LOCAL MEMBER OBJECTION & PETITION

APPLICATION No. **18/02698/MNR** APPLICATION DATE: 21/11/2018

APPLICANT: MR ANDREW BATES – GERAINT JOHN PLANNING
LOCATION: 19 LLANDENNIS AVENUE, CYNCOED
PROPOSAL: DEMOLITION OF THE EXISTING TWO-STOREY DWELLING AND GARAGE TO PROVIDE A 6NO. BEDROOM, THREE STOREY DWELLING WITH GARAGE, SWIMMING POOL, POOL HOUSE AND AMENITY SPACE

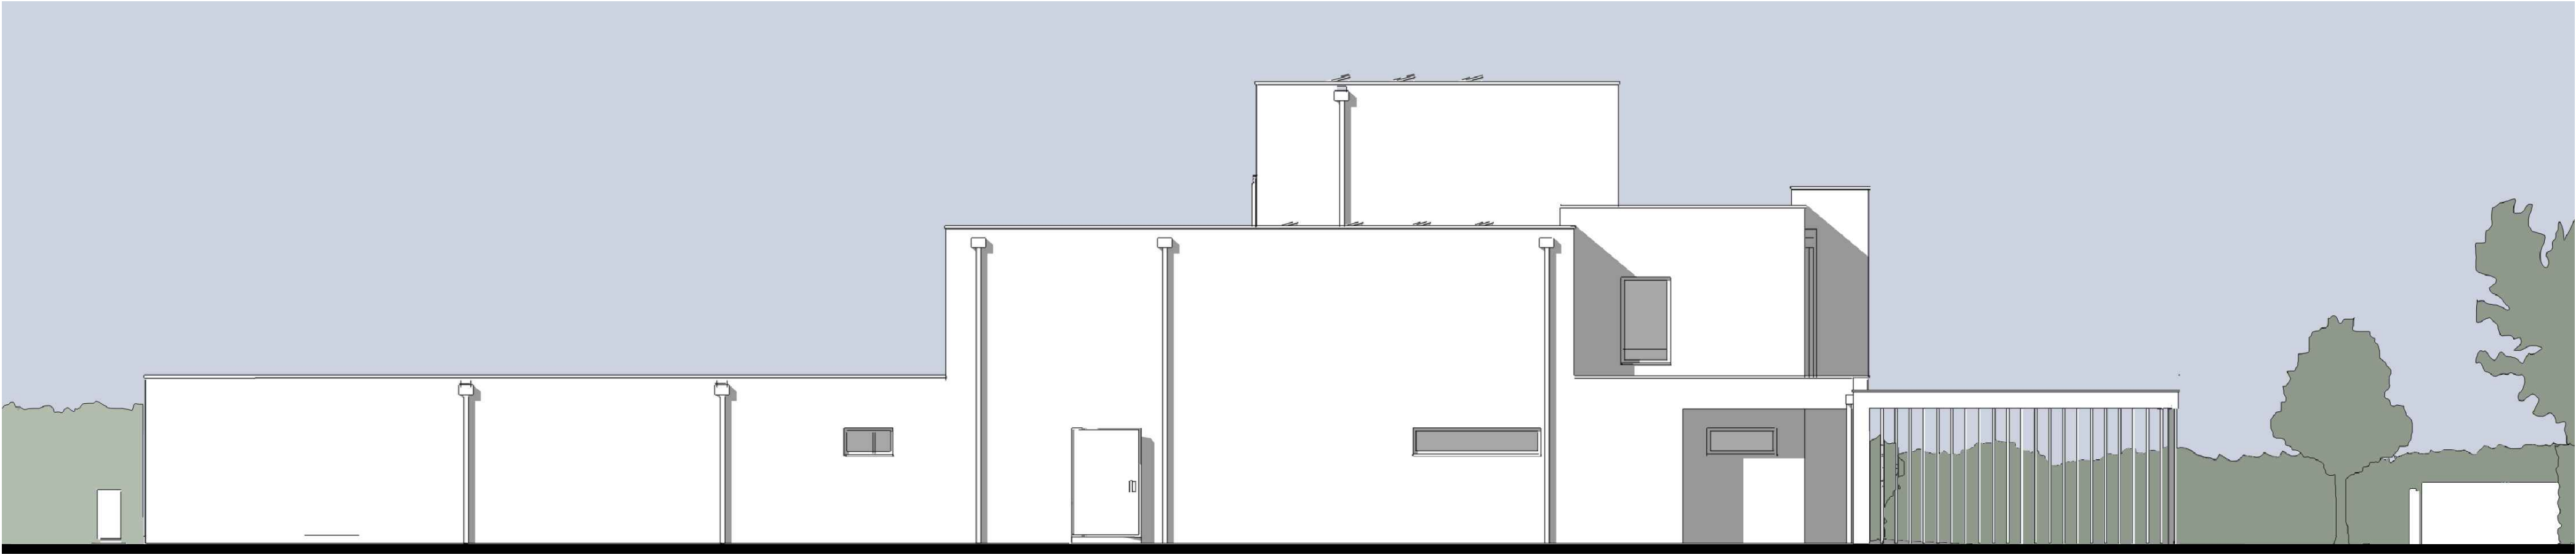
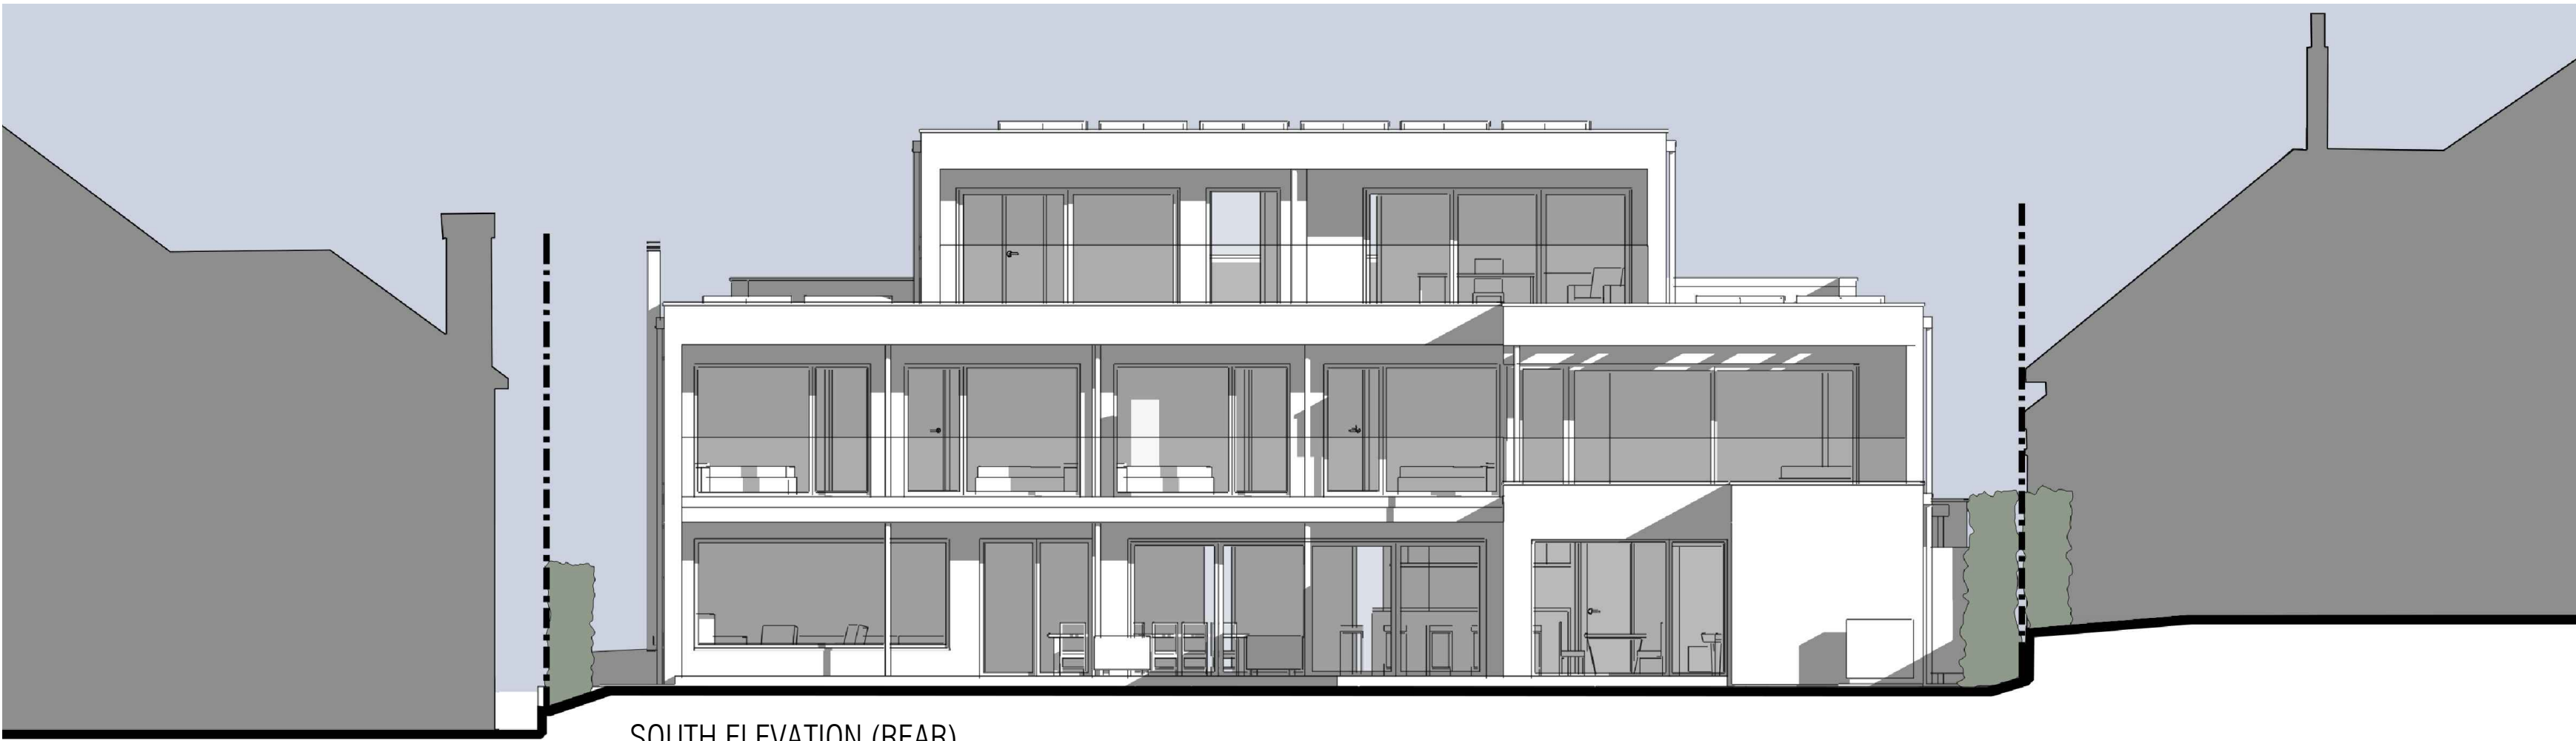
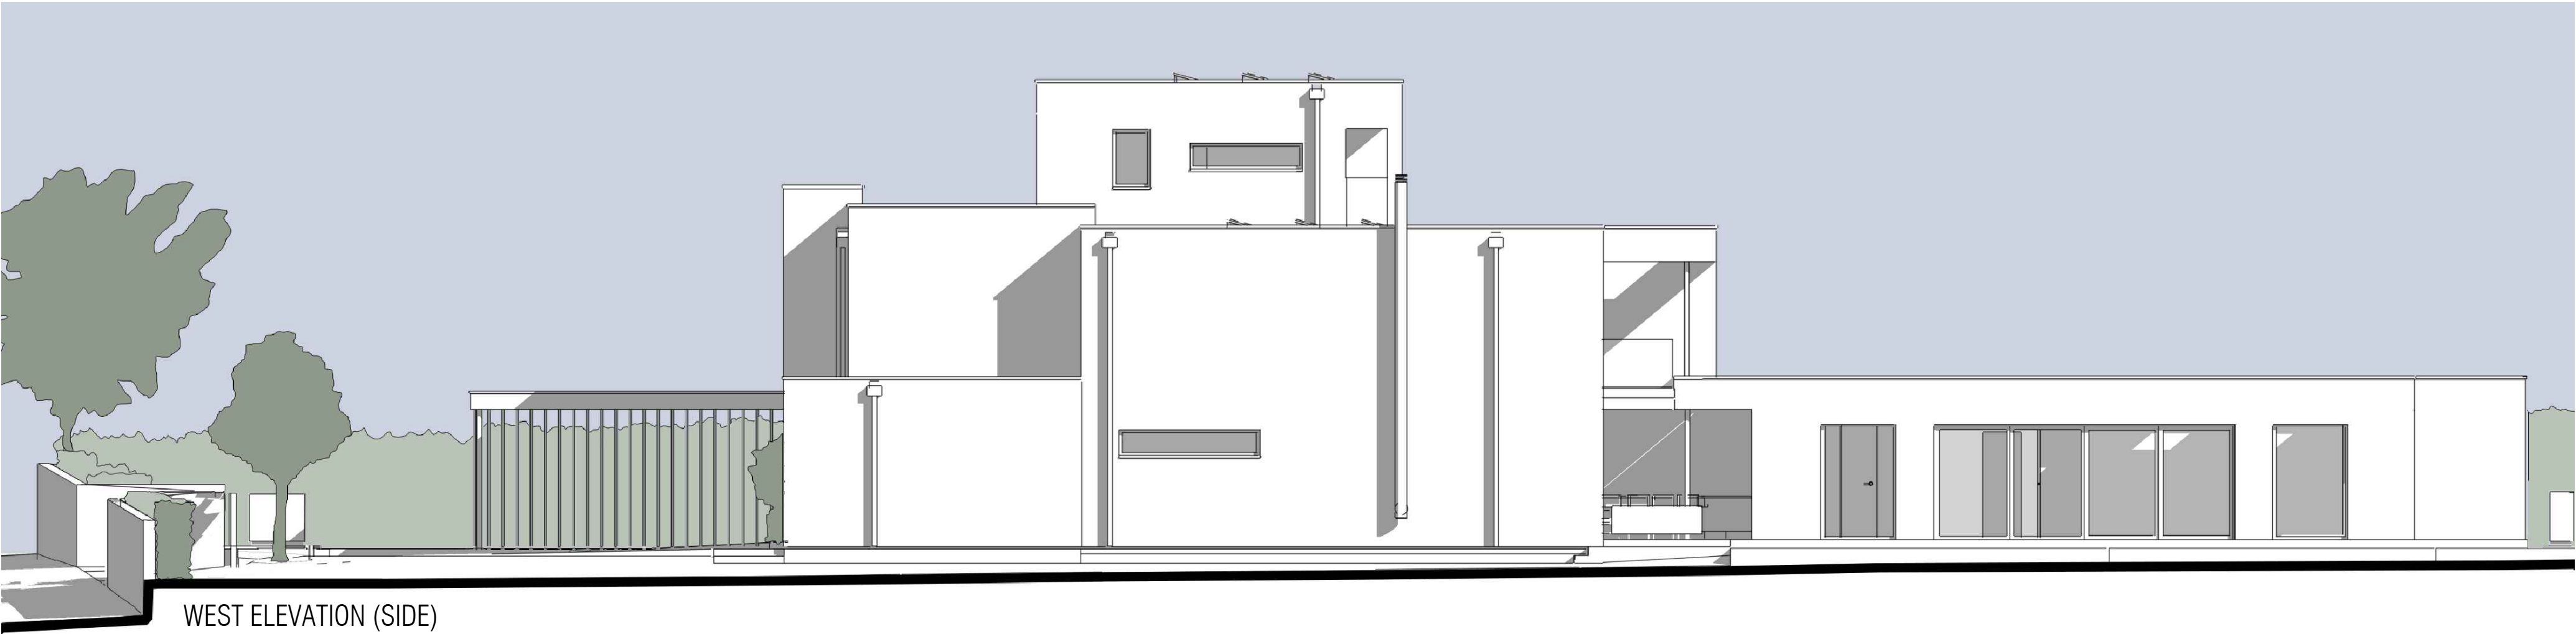
- The proposed dwelling, being of three storeys, is too high and disproportionately large.
- The proposal, a three-storey, flat roofed property, will overlook the handsome houses around it and will be out of character and place. Any new dwelling should be in keeping with the other houses in the road.

- The development is too large for the site and road, being significantly larger than the existing house on the plot.
- There are no other 3-storey buildings on this scale in the road and the flat roof design is not in character with the other properties in the road, which have pitched roofs.

- The third floor terrace of the proposed dwelling would provide a sightline into neighbouring gardens.

- 8.8 Whilst the existing dwelling on the site is two-storey, the proposed building would be approximately 1.5m taller than the existing dwelling at its highest point, despite being three-storeys. The dwelling would however be no taller than that of the ridge height of the neighbouring properties on either side, as is illustrated in the submitted 'Proposed Street Scene.' The height of the principal 2-storey element of the proposed dwelling would be approximately 1.5m higher than the eaves height of the existing property, though at a consistent height as that of the eaves height of no. 17. The second floor of the proposed dwelling, being set back and in, would also aid in reducing the perceived massing of the top floor of the building. Taking the above into consideration, the height of the proposed dwelling is considered acceptable within the context of the streetscene and considered to be consistent with the requirements of Policy KP5 of the adopted LDP in this sense.

- 8.17 The proposed dwelling would be of a flat roof contemporary design, however taking paragraph 3.16 of Planning Policy Wales into account and given that the scale, massing, siting and layout of the proposed development is considered to appropriately respond to the surrounding built form, it would be unreasonable to refuse this application on the basis of the contemporary design and flat roof finish proposed alone.
